**Notice of Allowability**

10/688,516

CHANG ET AL.

### **EXAMINER'S AMENDMENT**

FIG. 1

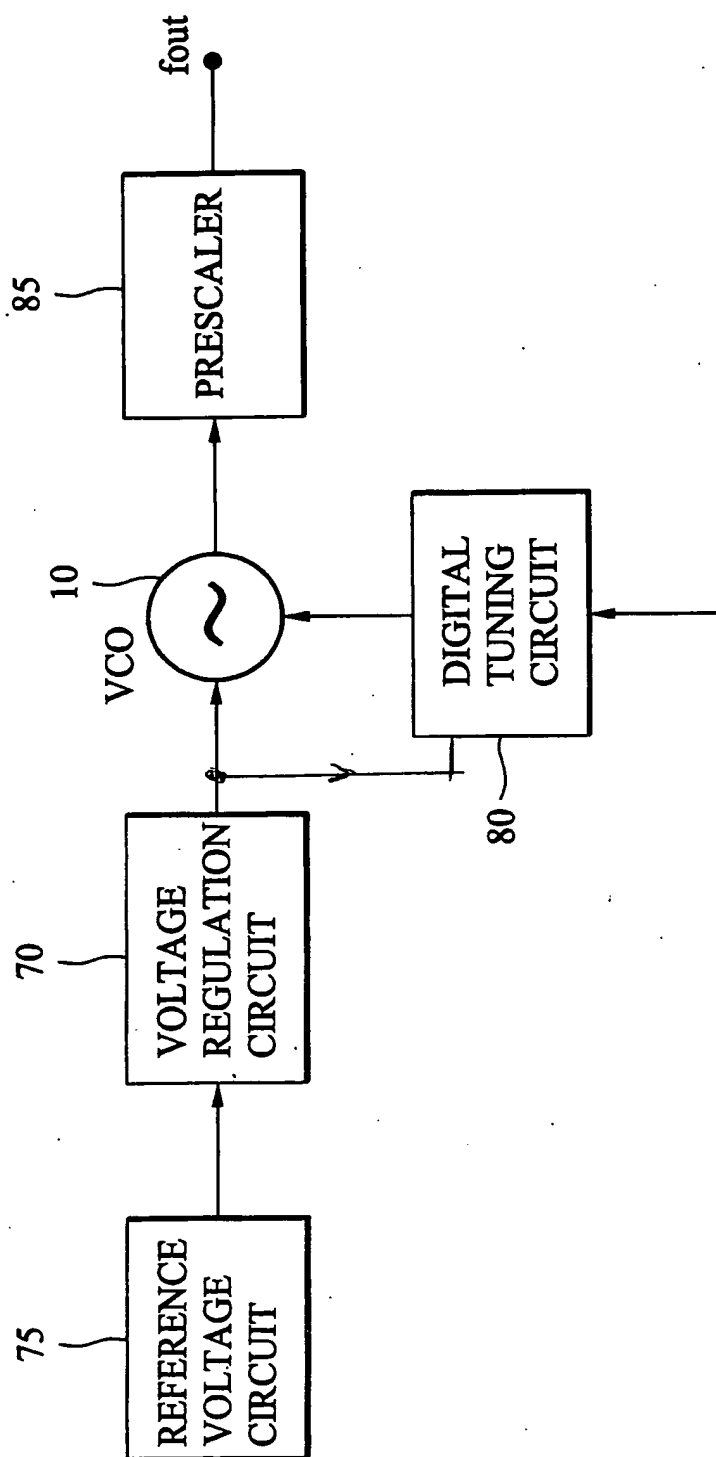
3. The following changes to the drawings have been approved by the examiner and agreed upon by applicant: the submitted drawings, figure 1, filed on 8/16/05 is disapproved. The original drawings, figure 1, will be used with a line connecting the output of the voltage regulation circuit 70 to the input of the digital tuning circuit 80 is added. In order to avoid abandonment of the application, applicant must make these above agreed upon drawing changes.
